Service Bulletin

No. : MZ04-058

Model: SR7300

Subject: 1. The Sound will MUTE when operation with a HDD Recorder.
2. The output level changes.

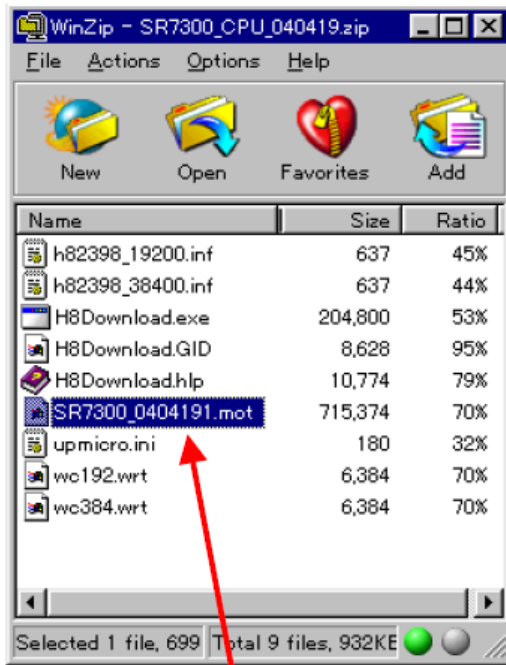
Symptom: 1.The Sound will MUTE when operating the HDD Recorder.

1) When connecting the SR7300 to a Panasonic® or Toshiba® HDD Recorder through a Digital connection, when operating the HDD Recorder the sound will Mute.

2. The output level changes.

1) When the SUBWOOFER is chosen as NONE in SPEAKER SETUP and Press the 7.1/6.1 CH INPUT button during S-Direct operation, the output level will change.

Solution: Update the firmware.

1. Update the CPU (QU01) firmware version to "V040419_1".
2. Update the DSP (Q601) firmware DSP CODE ID 02 to "CD02 02010116".
3. Please refer to the SR7300/SR7300F/PS7300 service manual on page 53 "10.UPDATE FIRMWARE" for details.
